# PRODUCT CHANGE NOTICE

Change Notice No. 199  
Implemented By: OM  
Date: 7/1/15  
Effective: 7/10/15

Component Product Title: Ithaca Stool and Ithaca Ultra Stool J-bar and Mechanism.

## Ithaca Task Stool OEI65

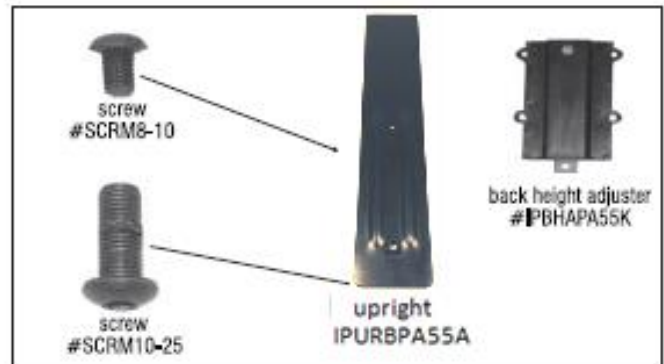
Current J-bar And Mechanism Tail Bracket	CURRENT_URBPAS5K BACK UPRIGHT	New Wider J-bar And Mechanism Tail Bracket	NEW PART #_URBPAS5A BACK UPRIGHT
# MCHCLS Current Mechansim	 89.4 mm 3 1/2"	NEW PART # MCHCLSA Mechanism	 89.4 mm 3 1/2"
72.2 mm 2 7/8" (2.84)	72.2 mm 3 1/2" (3.51)	89.4 mm 3 1/2" (3.51)	89.4 mm 3 1/2" (3.51) ATTACHMENT AREA

Reason: Added Strength in Chair Back. Passes All ANSI/BIFMA Testing.

- Customer who order by kit model numbers, you will receive new parts in BOM.
- Customers who have inventories of parts (Kits) use up old parts as a running change.
- Customers replace existing assembly flow charts in project books with new charts.
